LETTER 04 ADAMS BROADWELL JOSEPH & CARDOZO

On behalf of **Silicon Valley Residents for Responsible Development** ("Silicon Valley Residents"), we submit these comments on the Draft Environmental Impact Report ("DEIR") for the San Jose State University ("SJSU") Campus Master Plan (SCH No. 2023030435) ("Project") proposed by the California State University ("CSU") Board of Trustees ("Trustees").

Response O4-1

Inconsistent Project Student Population Assumptions in DEIR

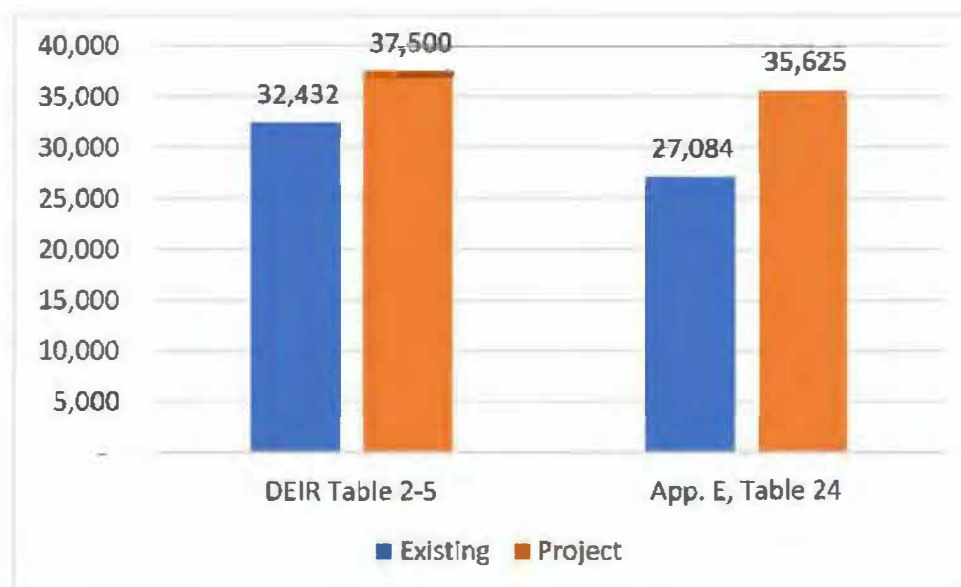
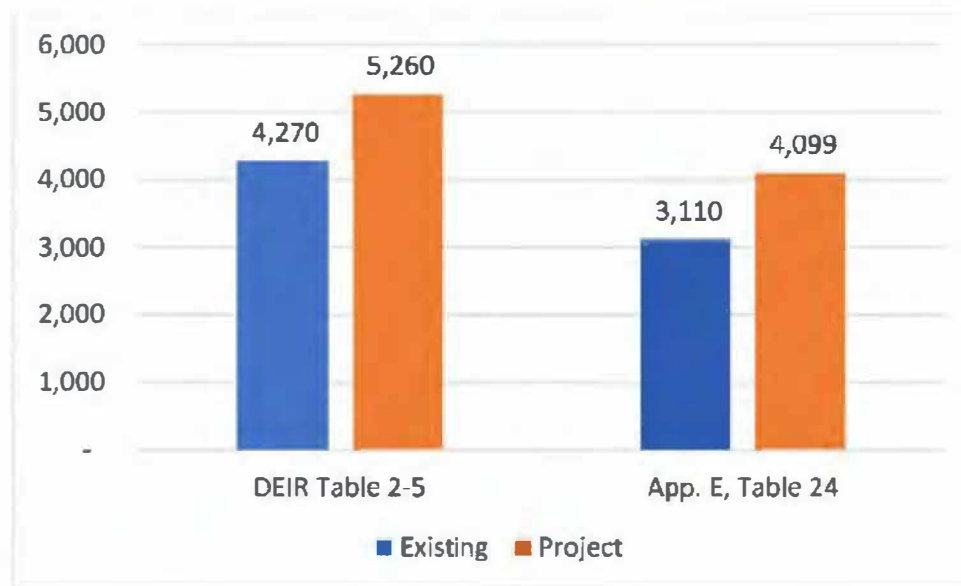
The numbers between the two tables reproduced do not match for either students or employees as summarized in the two tables below.

Response O4-50

Figure 1: Area Used in LODES Mapping

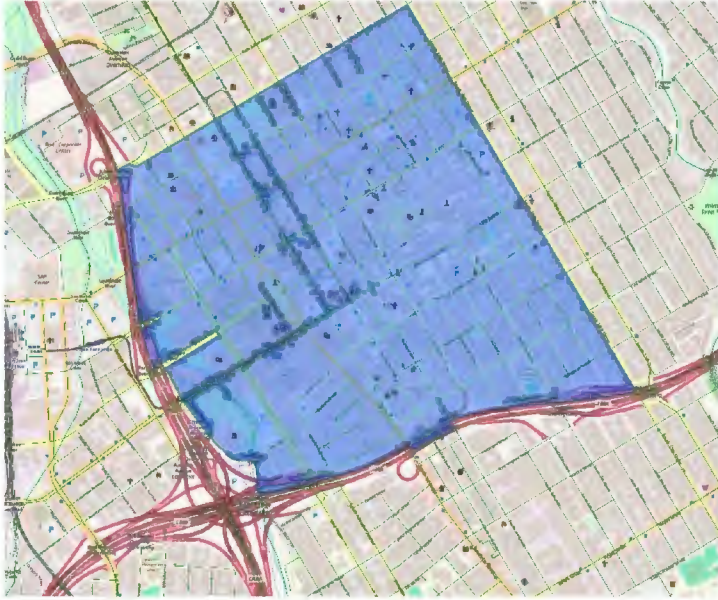
Focusing on workers commuting to the project area mapped in Figure 1, Figure 2 shows current home locations from 2022 LODES data (the most recent).

Figure 2: Workers' Home Locations for Jobs in Project Area Shown in Figure 1¹

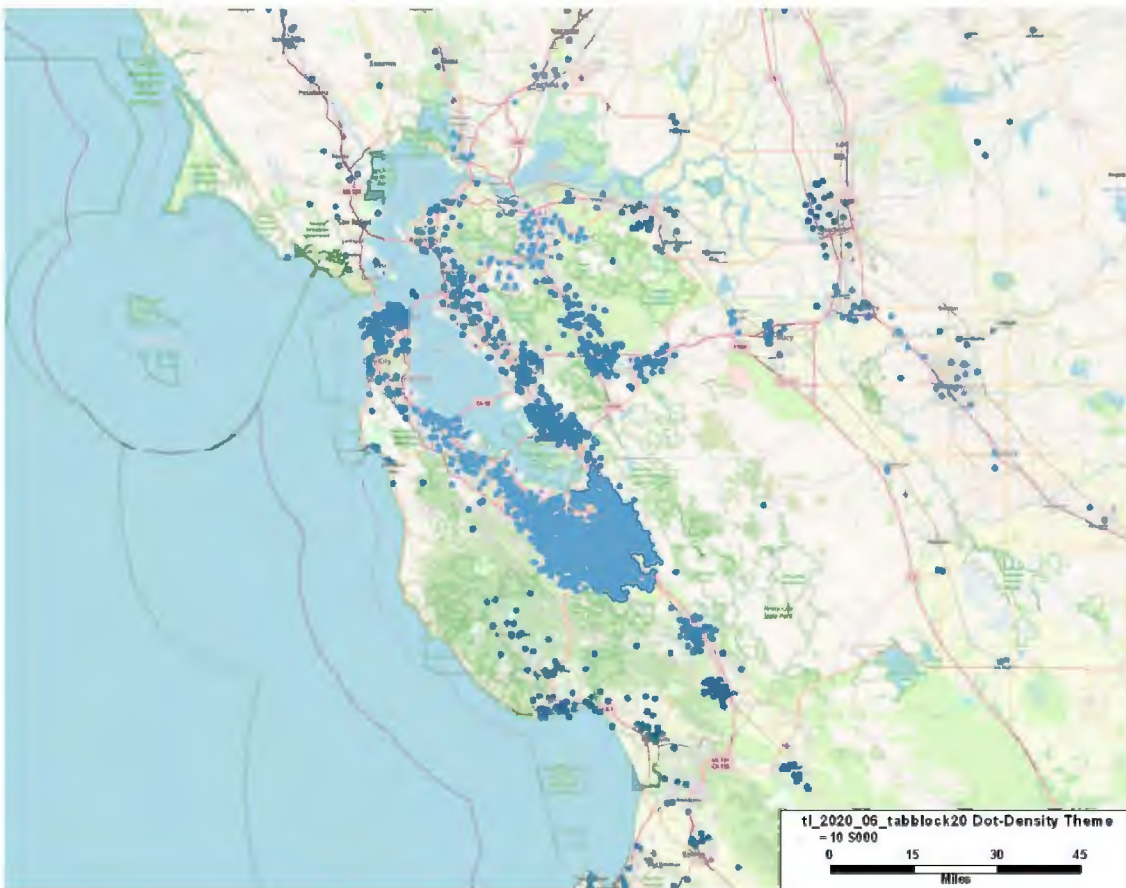
As shown in Figure 2, there are many workers in the project area who live in the City of San Jose, but also large clusters with much longer commutes. A primary reason for these long commutes is a shortage of workforce housing in the City. An excerpt from the City's Draft Housing Element states:

Figure 2-1 from the Draft Housing Element shows a required income of \$93,320 to rent a one-bedroom apartment in the City.

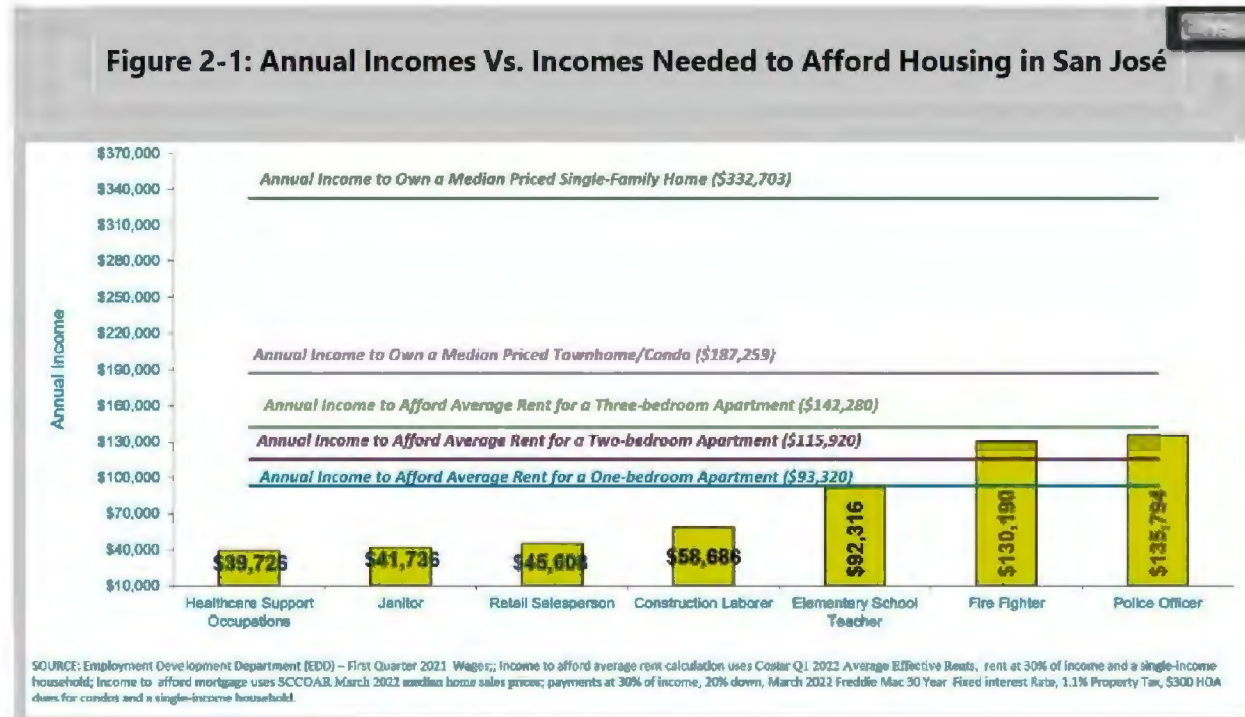
San José continues to be one of the most expensive places to live in the country, with median housing prices pulling ever further out of reach for essential workers. In the first quarter of 2022, the median single-family home was \$1.7

million, the median condo/townhome was \$900,000, and median monthly rent was \$2,595. Figure 2-1 shows how these housing costs are unaffordable for a cross-section of workers who are essential for the continued functioning of our economy and society.²
